**SACRAMENTO MUNICIPAL UTILITY DISTRICT
UPPER AMERICAN RIVER PROJECT
(FERC PROJECT NO. 2101)**

**TECHNICAL REPORT ON
IOWA HILL PUMPED-STORAGE DEVELOPMENT
TURBIDITY ANALYSIS**

Appendix B - Peer Reviewer Comments to Draft Report and Responses from Authors

Appendix B - Peer Reviewer Comments to Draft Report and Responses from Authors

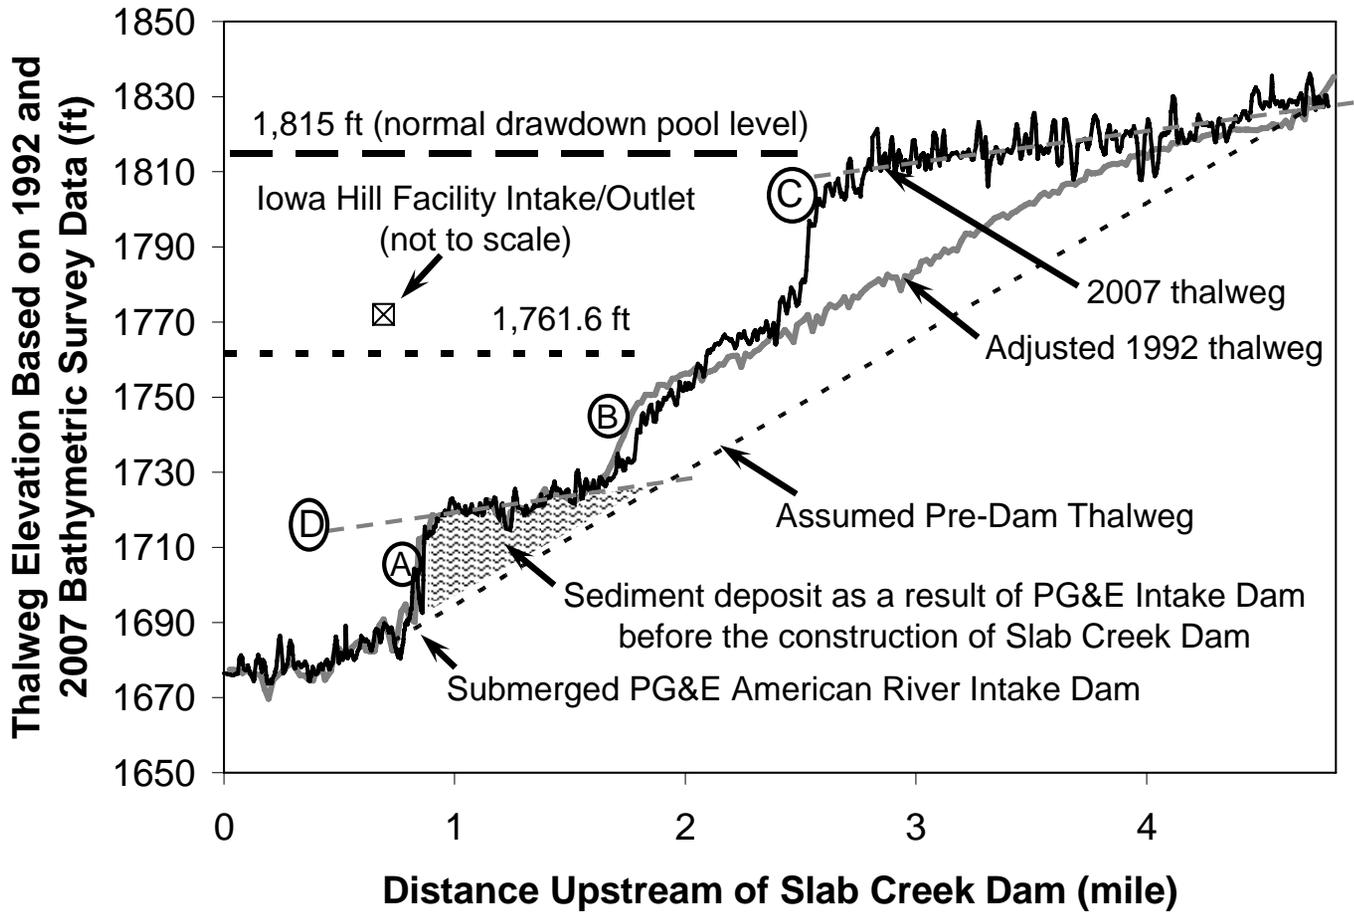
“The statement that ‘...there has been minimal fine sediment deposition downstream of the deltaic front (p. 7)’ is largely based on the surveying error assumption, and the adjusted bathymetry (Figure 9) is used to support the statement. I would suggest adding a clause such as “. . ., assuming our adjustment of the 1992 profile is accurate’.”

Revised as suggested.

Figure 10: Reservoir cross-section 0.5 miles upstream of Slab Creek Dam, based on 1992 bathymetry survey data.

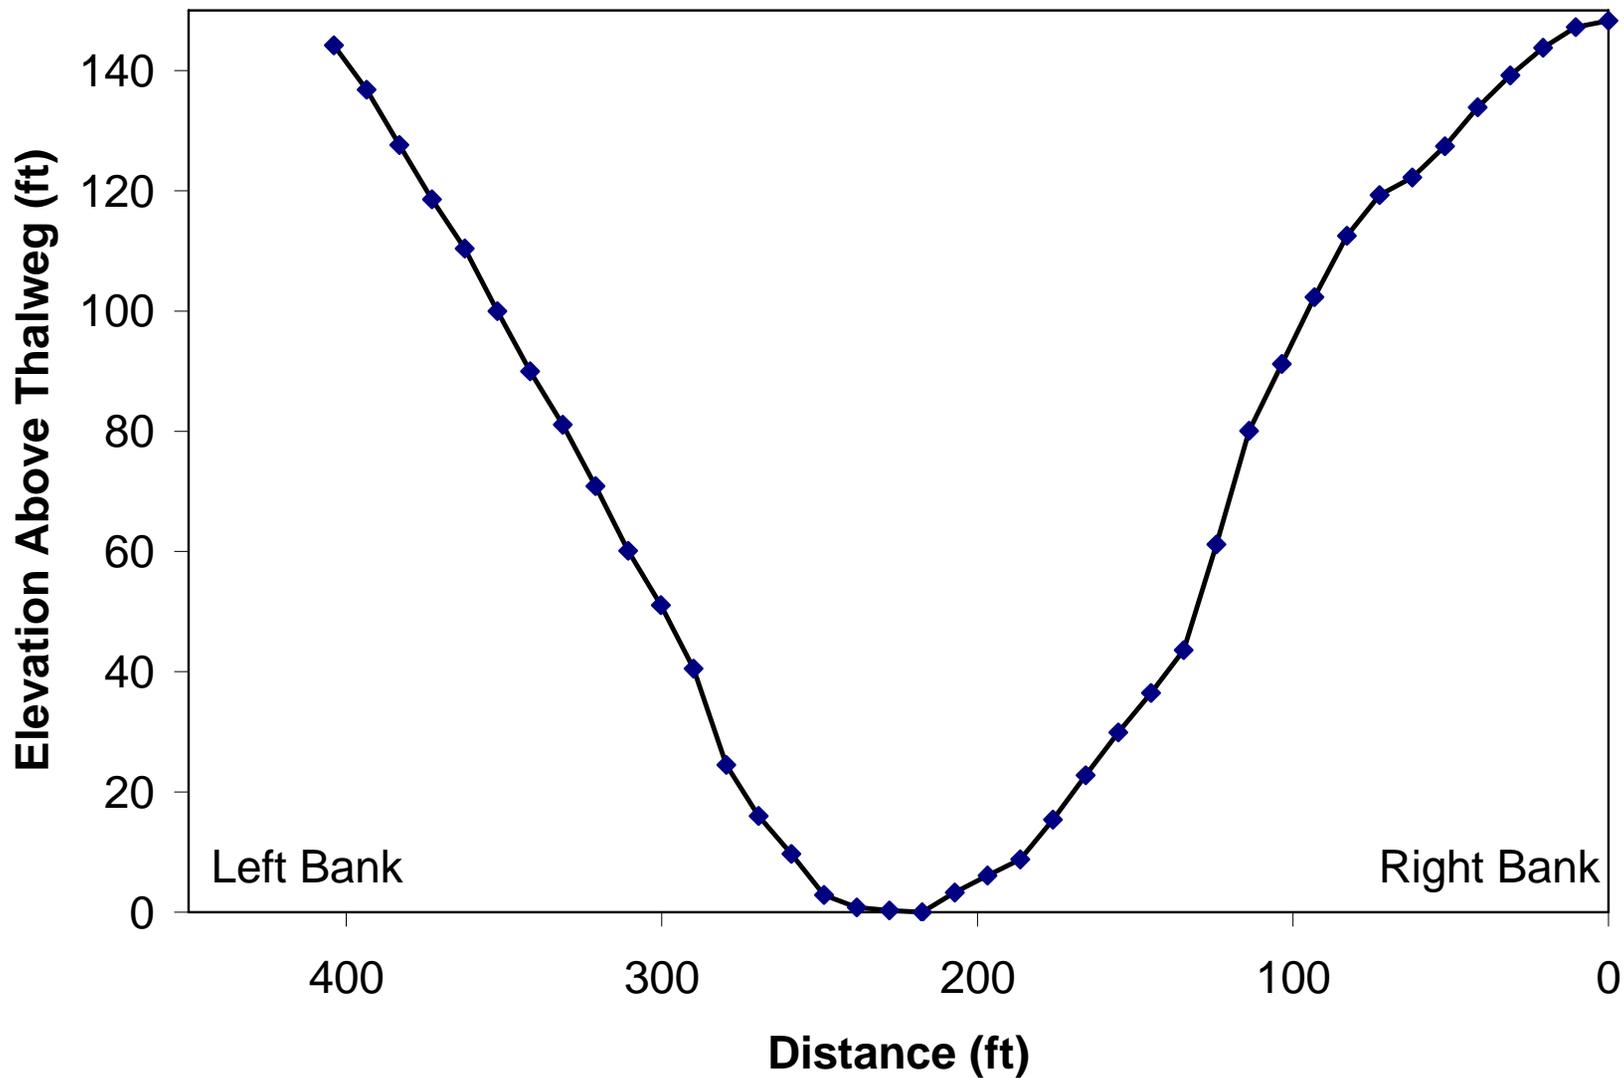
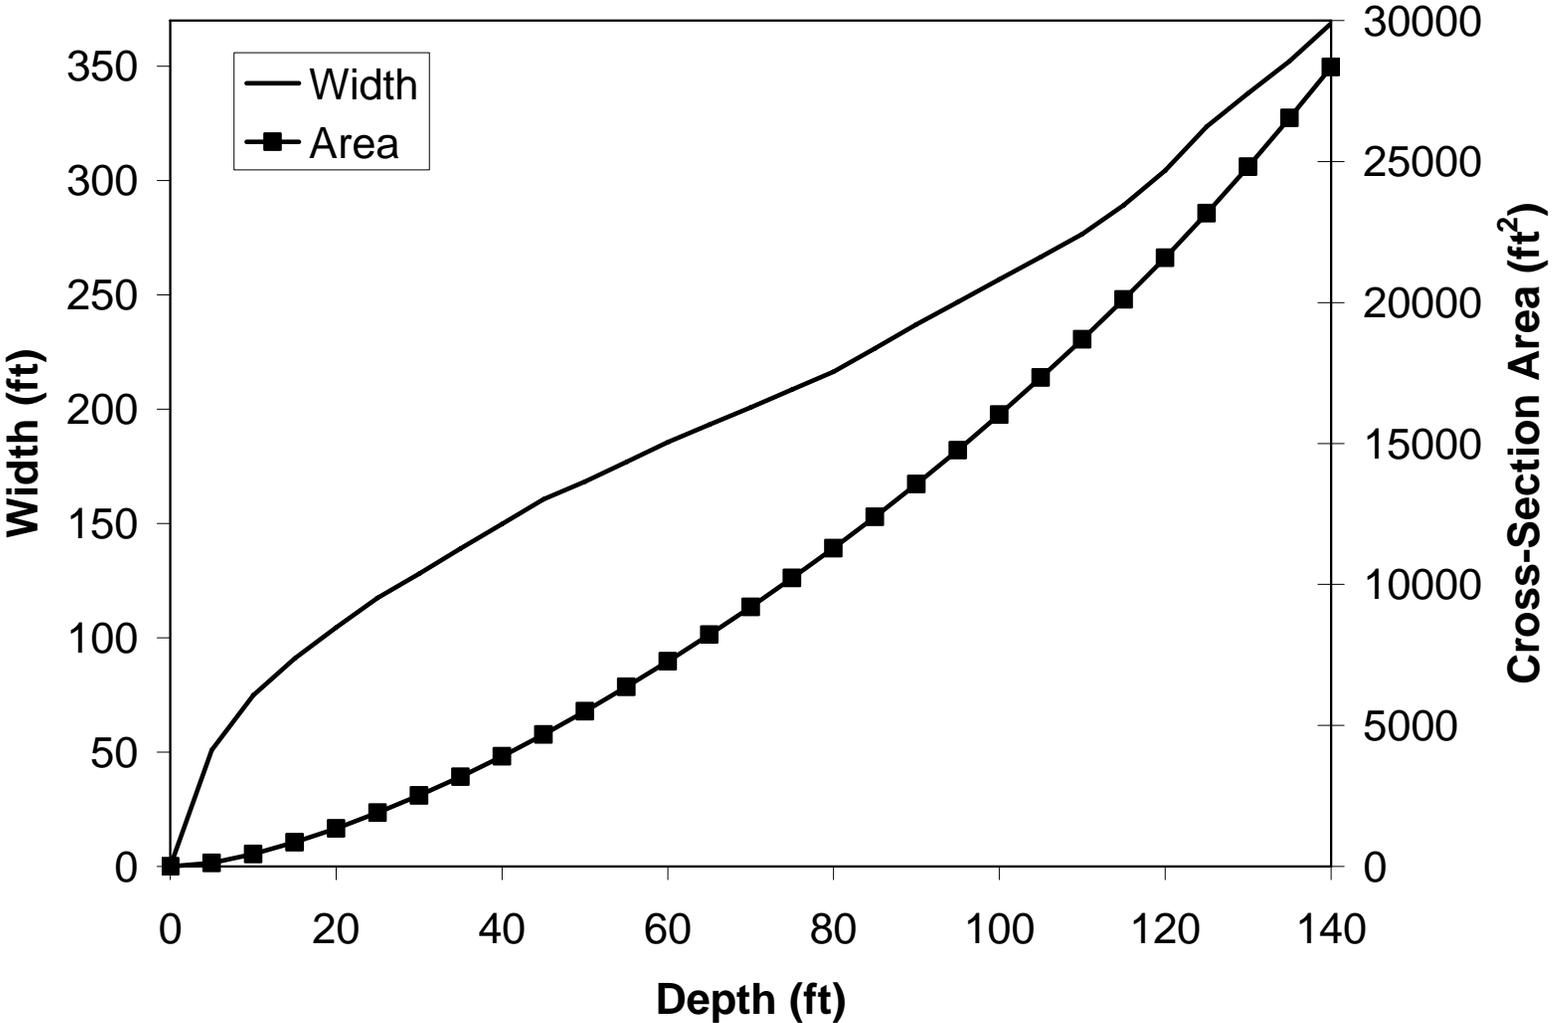
“The report states that Slab Creek Reservoir “has a relatively consistent shape” to justify the use of a single cross section to estimate width-depth-area relationships, which are then used to estimate reservoir sedimentation rates. In Figure 6, however, the reservoir appears to narrow in an upstream direction. Further, the cross section used to determine a depth-area relationship is near the dam (0.5 miles upstream), whereas most deposition has occurred upstream, in the narrower portion of the reservoir. If one or more cross sections are available from the upstream portion of the reservoir, where sediment deposition is most active, incorporating those into the analysis may improve estimates of reservoir sedimentation rates and/or provide additional insight into uncertainties.”

The reservoir appear to narrow in the upstream direction because it becomes shallower in the upstream direction, which is consistent with our assumption (i.e., the deeper the reservoir the wider the assumed width, as shown in Figures 10 and 11). Using a single cross-section is necessary because buried pre-Slab Creek Dam cross-sections are not available (see responses to Dr. Singer’s earlier comment for more detailed discussions).

Figure 14: Predicted sediment deposit profiles in the reservoir over the next 150 years under normal reservoir operation (i.e., maintaining water-surface-elevations between the maximum normal pool level and the normal drawdown pool level) and a sediment accumulation rate of 38,000 yd³/yr.

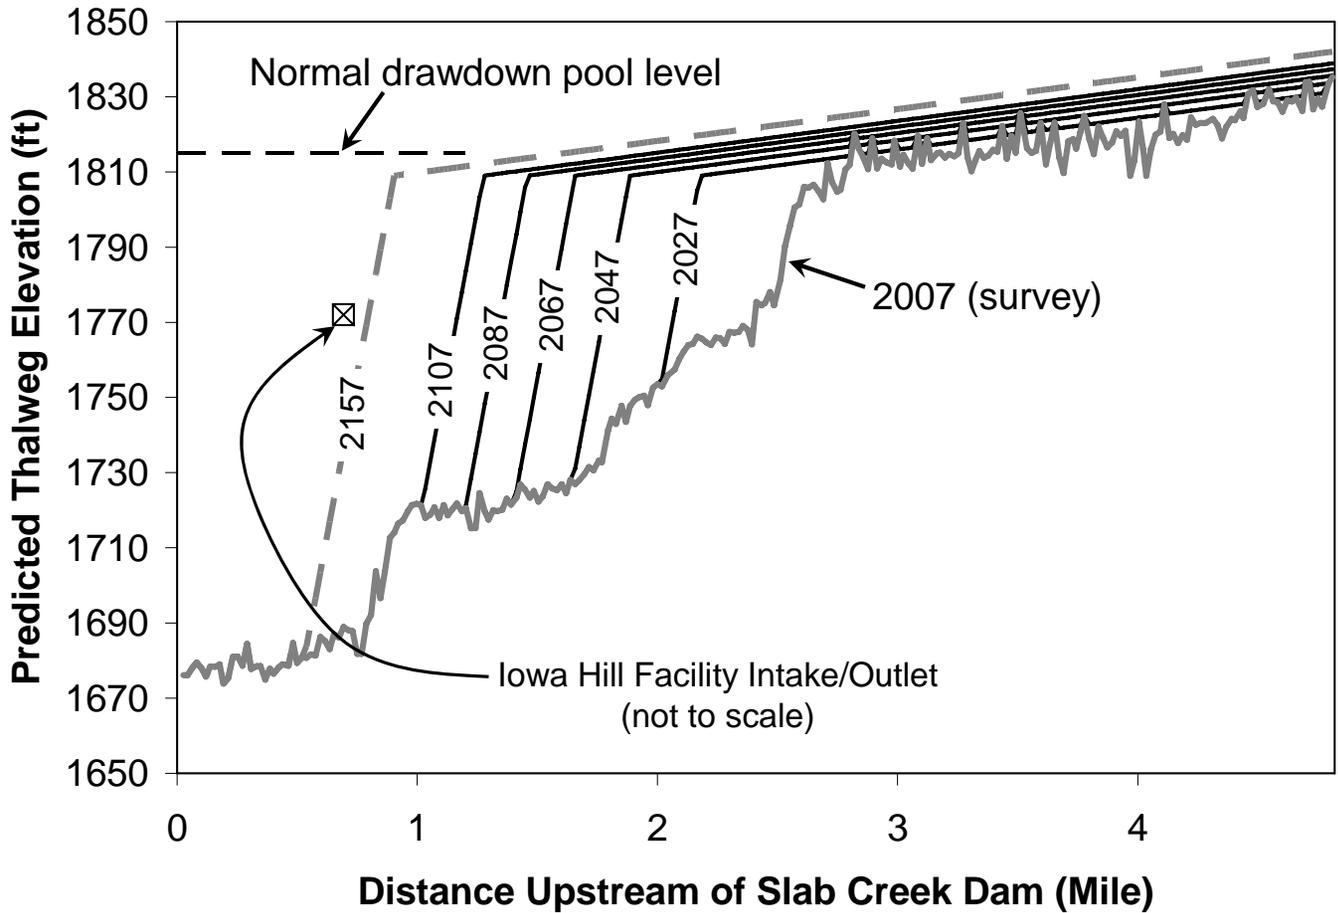
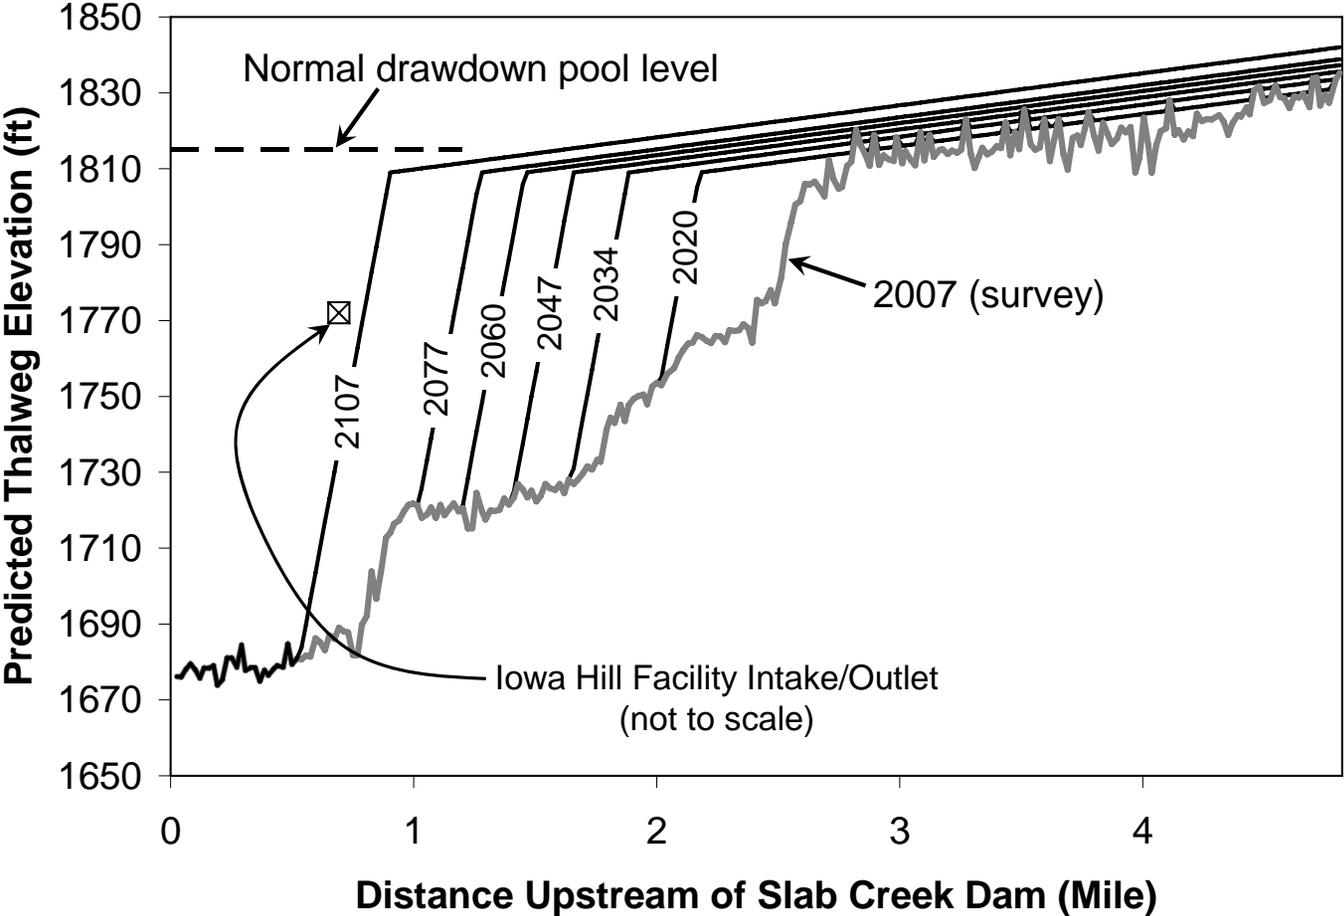
“The analysis of advancement of the delta front does not appear to account for upstream propagation of the delta. The reduced energy gradient in the upstream end of Slab Creek Reservoir could cause upstream sediment deposition, especially of coarse sediment. Uncertainty in the 1992 and 2007 surveys may preclude conclusions about upstream sediment deposition, but field observations, coring, and aerial photograph analysis could provide insights. If some sediment deposition was occurring upstream, and/or increasing the topset slope of the delta, this could potentially reduce the rate of delta advance.”

Upstream progradation of the delta is accounted for, as demonstrated in Figure 14 and more clearly seen in Figure 15. The upstream progradation of the delta is associated with the slow and persistent aggradation of the topset of the delta deposit. Although the topset deposit should

always have a concave profile (i.e., bed slope increases in the upstream direction, e.g., Cui et al. 1996, Cui et al. 2005), this is a short distance and the effect from the concavity is very minor, and a constant topset slope should provide adequate approximations, as demonstrated in Figures 12, 13, and 14.
